Amendments to the Drawings:

REMARKS

Title: Differential and Differential Case
Inventors: WATANABE et al. et al.
App. No.: 10/780,587
Docket No.: 023971-0377

FIG.2

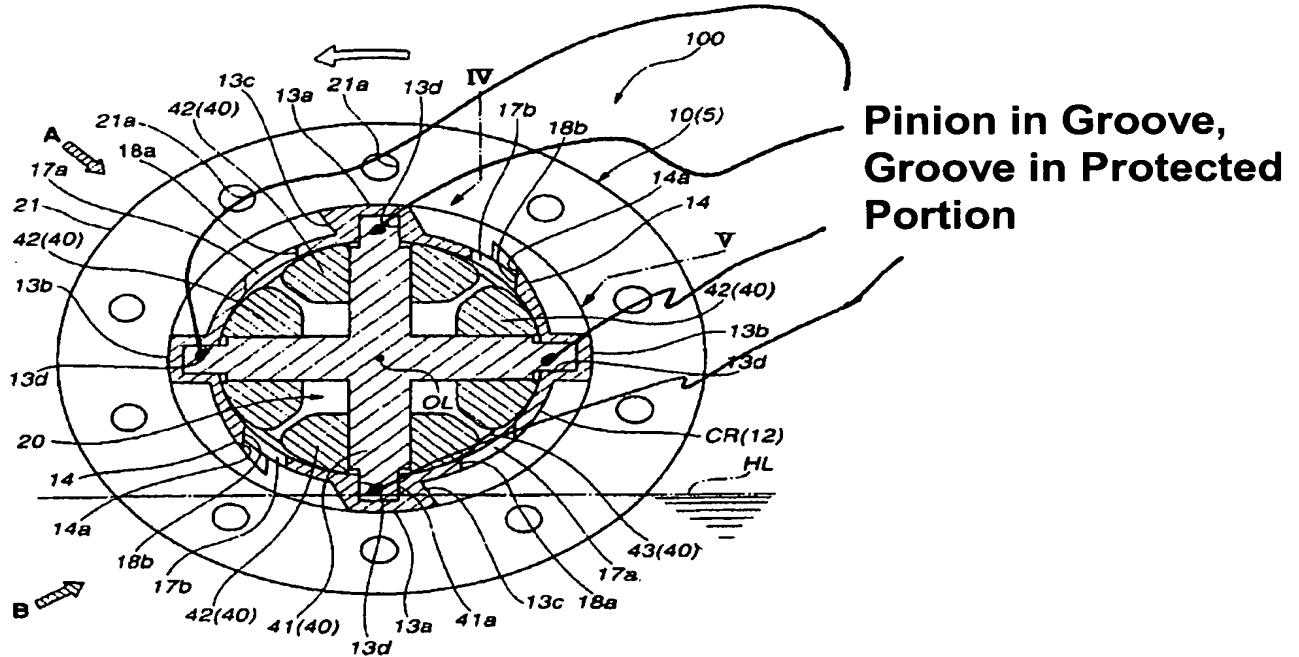
Regarding claim 9, Figs. 2, 3(A), 5(A) and 5(B), show second projected portions 13b as claimed, and the amendments to claim 9 clearly overcome the objection to the drawings.

Claim 1 recites a differential for a wheeled motor vehicle that includes, as distinguishing features from Porsche, “first projected portions formed on an outer surface of the differential case at portions that support . . . pinion shafts through . . . grooves,” where, as is earlier recited in claim 1, the “grooves [are] for respectively receiving therein the pinion shafts.” In an exemplary embodiment of the present invention, as is depicted in Fig. 2, the first projected portions 13a are formed at portions that support the pinion shafts (see the radially leading ends of pinion shafts of the pinion shaft unit 41, which protrude into cavities (grooves 13d) of the first projected portions). Below is an annotated reproduction of Fig. 2 from Applicants’ application, which clearly shows the cavities (grooves 13d) in the projected portions.

FIG.4(B)

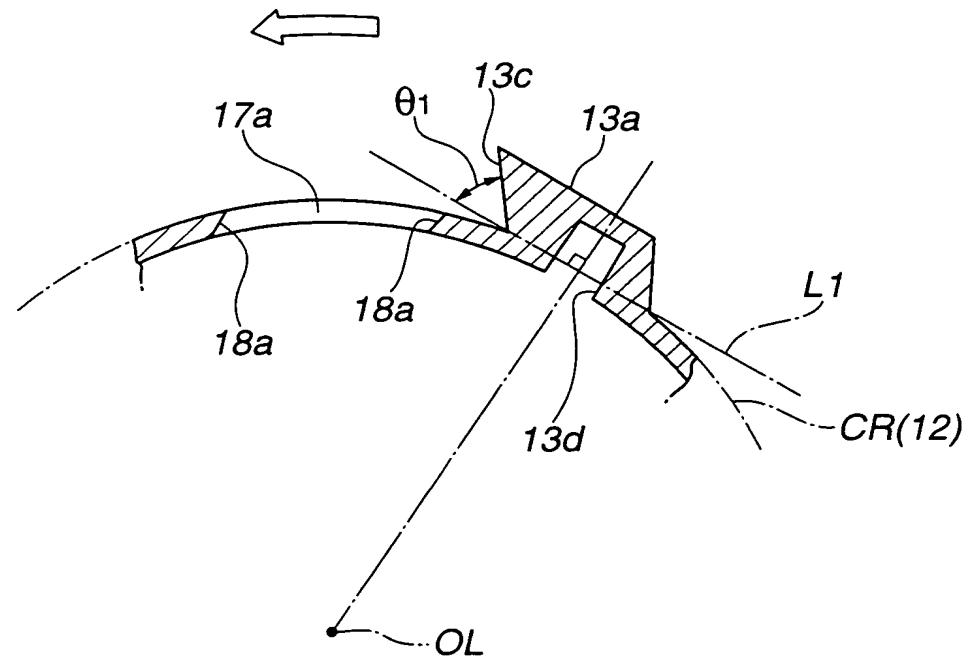
The specific changes which have been made to Figure 4(B) is the incorporation of an angle symbol along with the identifier “ θ_3 ”.

In the Office Action, the drawings are objected to as allegedly failing to show every feature present in the claims.

The amendment to Fig. 4(B) introduces the angle symbol along with the identifier “ θ_3 ”, and clearly identifies an obtuse angle as defined by the angle between surface 18a and the tangential line L2.

Please replace the drawing sheet bearing Fig. 4(A) and Fig. 4(B) with the corresponding revised drawing sheet presented in Appendix A of this paper.

In response, in order to advance prosecution, and without prejudice or disclaimer, Applicants have amended Fig. 4(B) as shows above, and also amended claim 9 as shown above, and request reconsideration.
